Serial Nr.: 10/699,547

## AMENDMENT'S TO THE DRAWINGS:

REMARKS

FIG. 1

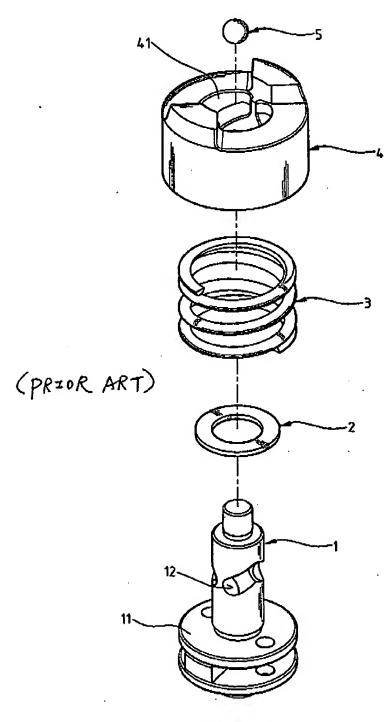
FIG. I is amended to include a legend —Prior Art-- as marked in the attached annotated drawing sheet showing marked-up changes.

FIG. 1 is amended to include the legend --Prior Art-- as shown in the attached annotated sheet for approval. A replacement sheet will be submitted by post office mail to ensure adequate quality for patent publication after the application is allowed. The new claims 3-6 are pending in the application and in full condition for allowance. Prompt and favorable reconsideration of the application is respectfully solicited.
